Amendments to the Claims:

Attachment: Replacement Sheets
Annotated Sheets Showing Changes

FIG. 1
PRIOR ART

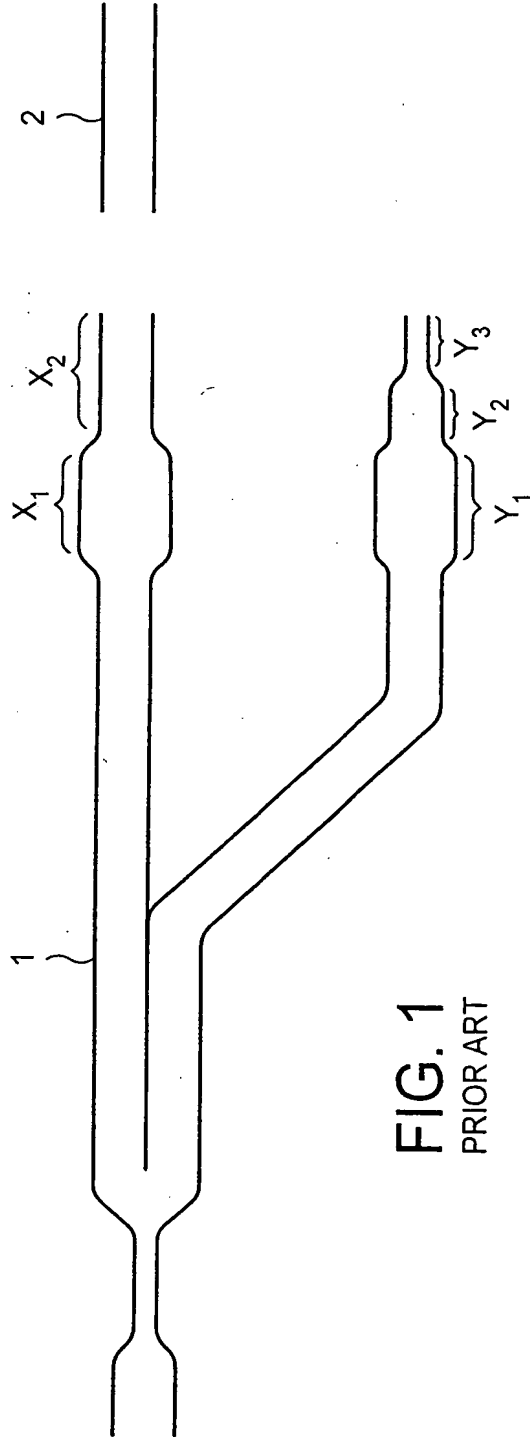
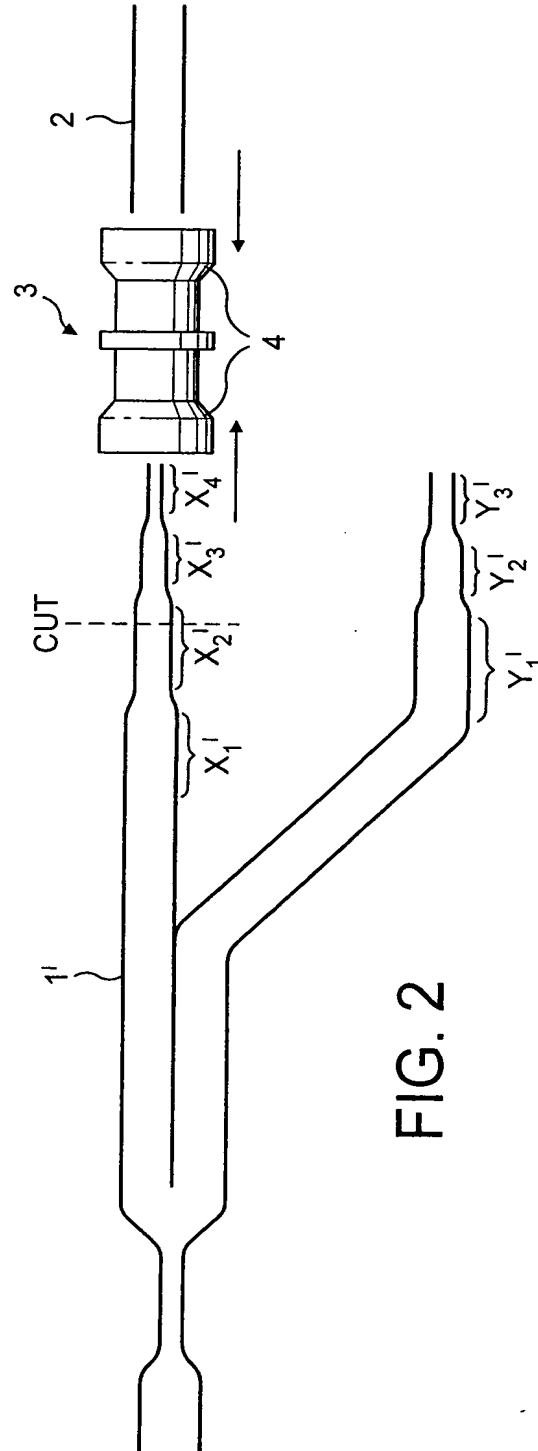
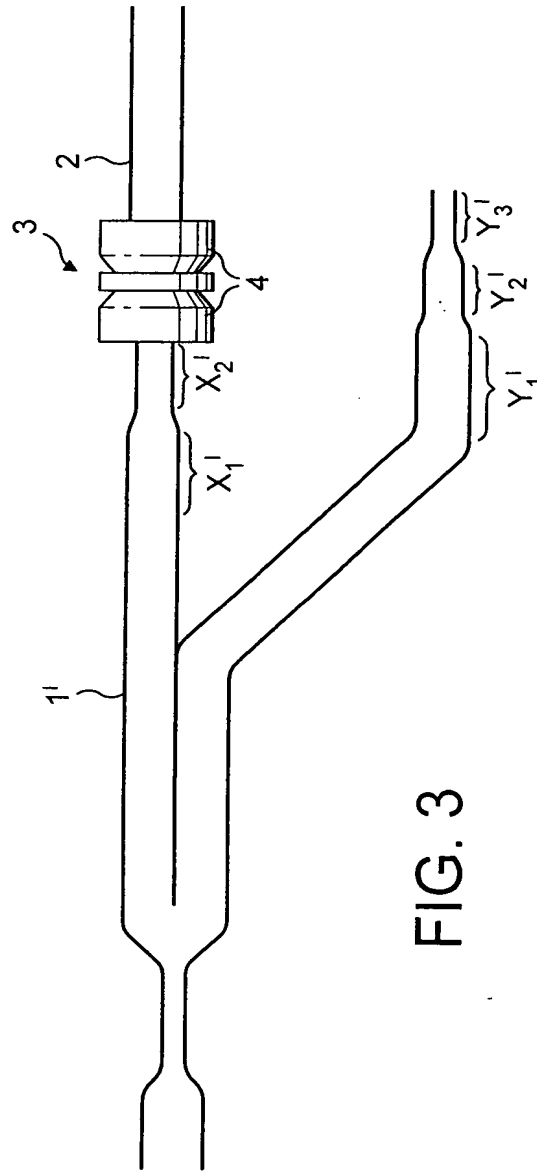
The attached sheets of drawings includes changes in Figs. 1-3. These sheets, which includes Figs. 1-3, replaces the original sheets including Figs. 1-3. In Figs. 1-3, the illustrated diameter of pipe 2 has been reduced.
